APPLICATION FOR A CERTIFICATE OF APPROPRIATENESS – STAFF REPORT

COA-0014-2019 407 N BLOUNT STREET

Nature of Project: Remove non-historic addition and stairs; construct additions on south and west facades; construct new side porch; enlarge parking area; add new rear walk

EXISTING TO PROPOSED BUILT AREAS		SF	% OF 13045 SF SITE
	EXISTING, INCLUDING SOUTH PORCH	3853 SF	29%
	PROPOSED	5073 SF	39%

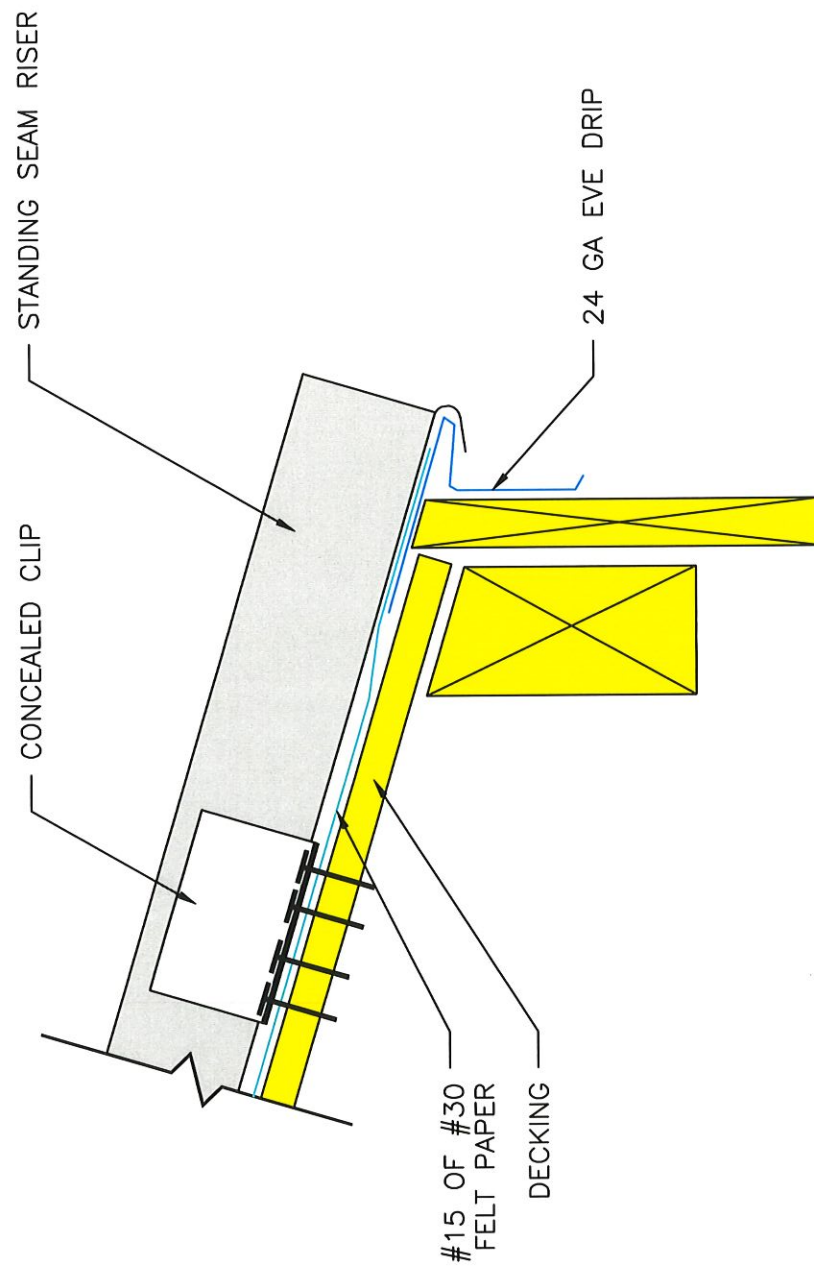
12* **Built area to open space analysis:** According to the applicant, the lot is 13,045 SF. Sanborn maps from 1914-1950 show approximately 3,450 SF of built area, with a ratio of built area to open space of 26%. The existing built area is 3,853 SF, with a ratio of built area to open space of 29%. The proposed built area is 5,073 SF, with a ratio of built area to open space of 39%.

15* Several mature trees were identified on a site plan; however, their critical root zones were not identified and no tree protection plan was provided.

Staff suggests that the Committee defer the application until a tree protection plan prepared by an arborist certified by the International Society of Arboriculture (ISA) or by a North Carolina licensed landscape architect that addresses the critical root zones and provides staging areas for construction activity and material storage is provided.

1. That a tree protection plan be implemented and remain in place for the duration of construction.
2. That porch footings be dug by hand and located to avoid damage to tree roots, should any be encountered during construction of the fence. Roots larger than 1" caliper will be cut cleanly using proper tools such as loppers.
3. That details and specifications for the following be provided to and approved by staff prior to construction or installation:
 - a. Window specifications;
 - b. Balcony railing details;
 - c. Brick walkway details.

407 N. BLOUNT STREET NORTH ELEVATION

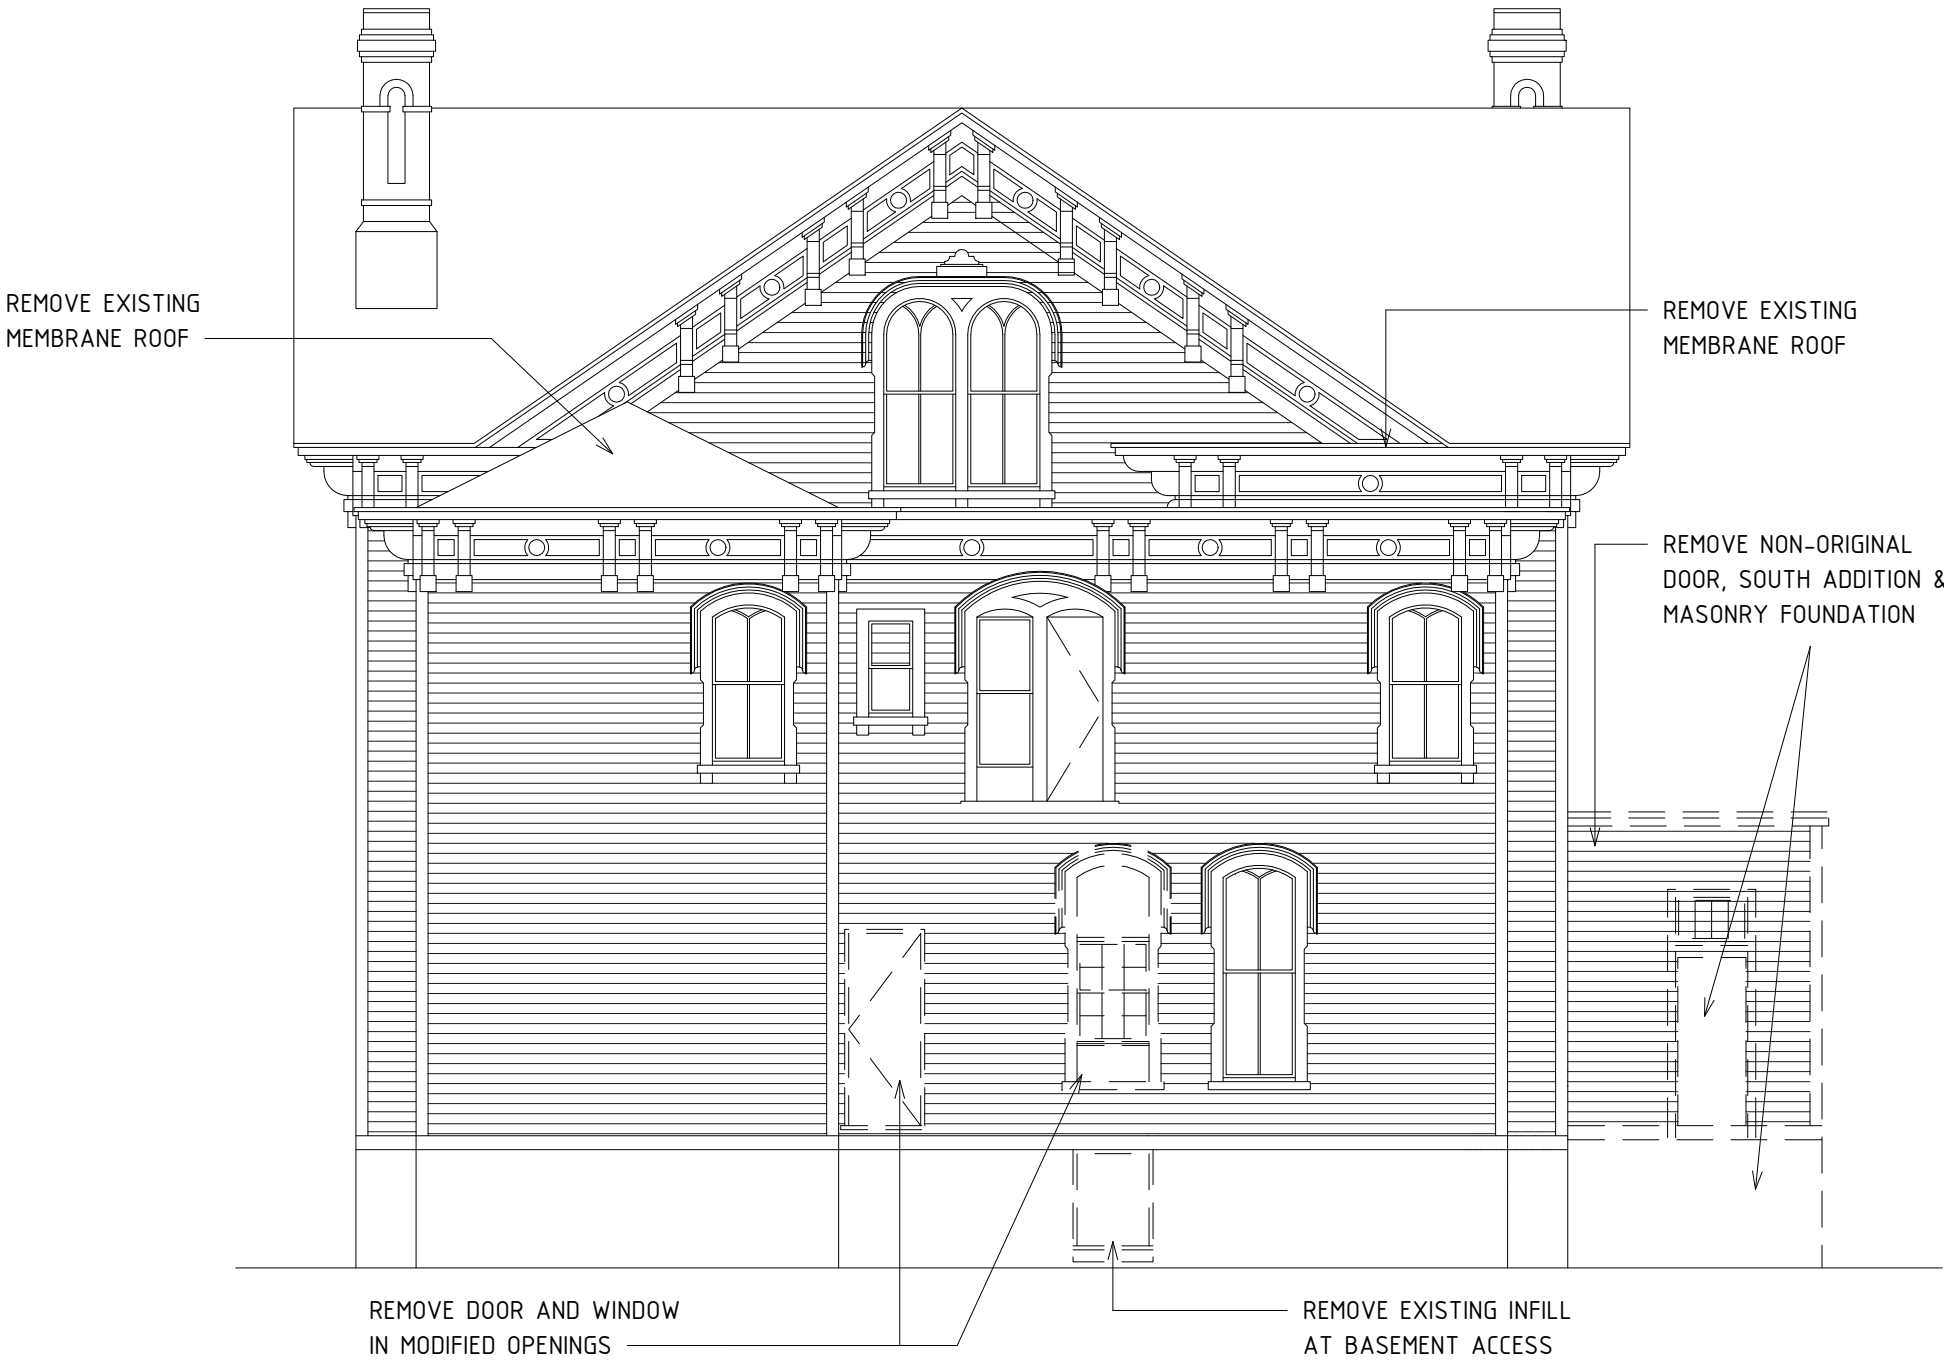
- 4* The elevations note that four non-historic infill windows on the north façade will be removed and replaced "to match existing." Photographs of the north façade were not provided. Window specifications were not provided.

407 N. BLOUNT STREET SOUTH ELEVATION
SCALE: 1/8" = 1'-0"

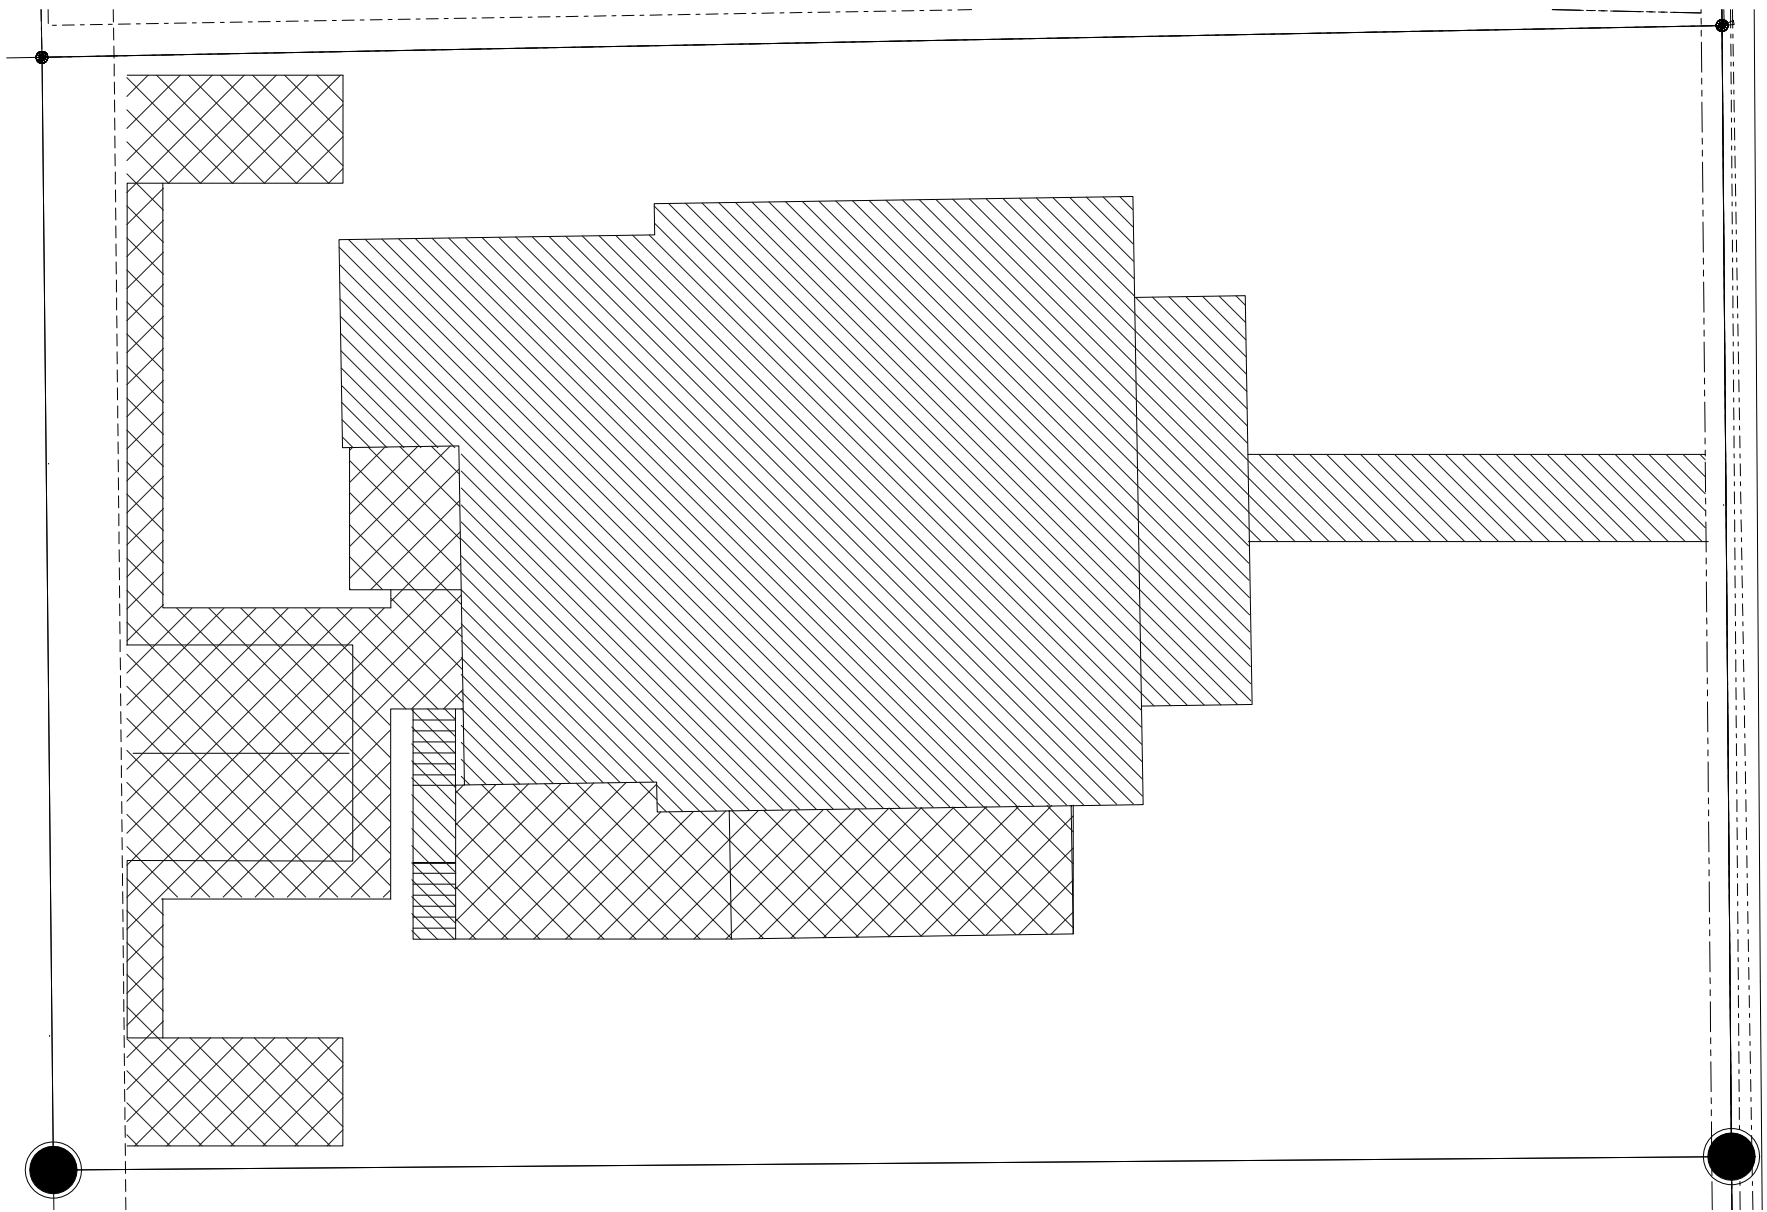
- 5* The proposed addition on the south façade is to be constructed on the extant historic stone foundation that remains from the original porch. The addition has the appearance of an enclosed reconstruction of the original porch design.

- 6* A new porch built on brick piers is proposed to extend from the addition along the south façade. The proposed porch design visually complements the historic structure by using simplified elements of the original porch design – specifically balustrades that resemble a lengthened version of the historic balustrade and columns – but does not present itself as a false historic addition.
